Subject: RE: New Tree Review Status for 2009 Lakeshore Dr. - 2016-156405 TP

LAKESHORE RESIDENCE

Board of Adjustments

NEW SETBACKS BY COA

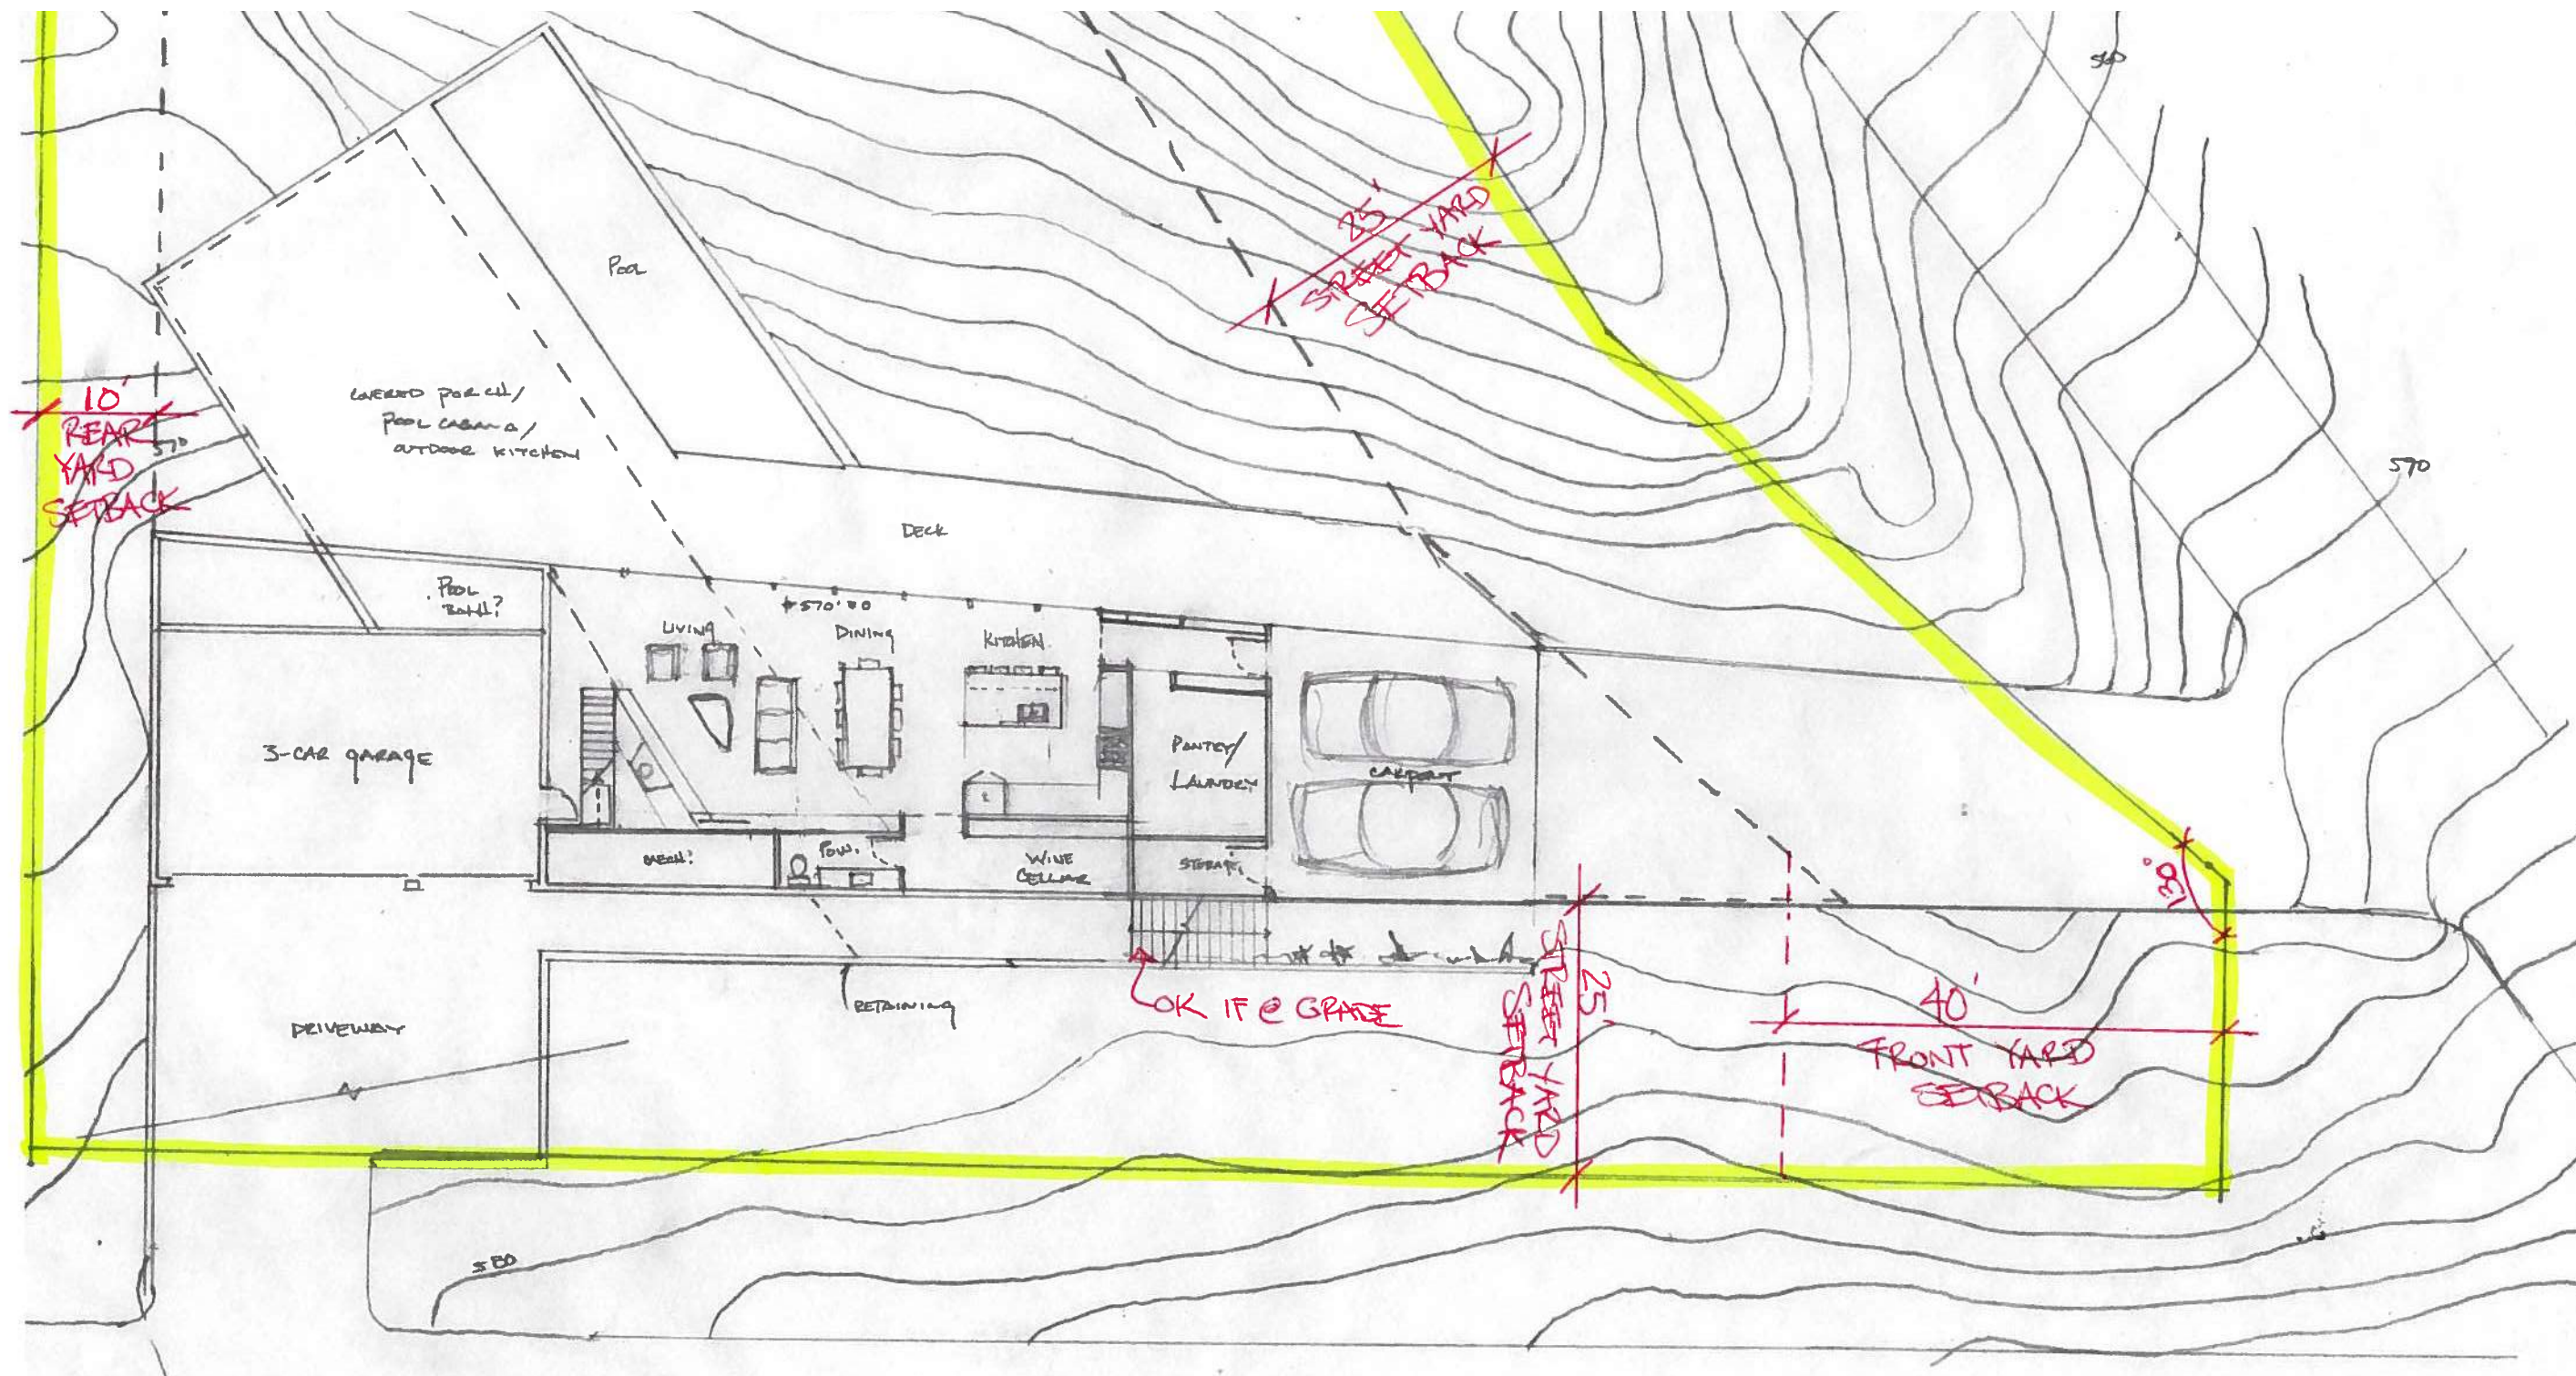
NEW FRONT YARD LOCATION PER CITY OF AUSTIN

“Since the angle between L2 and the adjacent property line parallel to Island Way is $<135^\circ$, L2 is the front property line. As such, its setback is 40’. The setback from each respective street is 25’. However, with L2 being the front property line, the interior property line is then the rear property line requiring a 20’ setback. If a 10’ setback is desired, a BOA variance will need to be sought.”
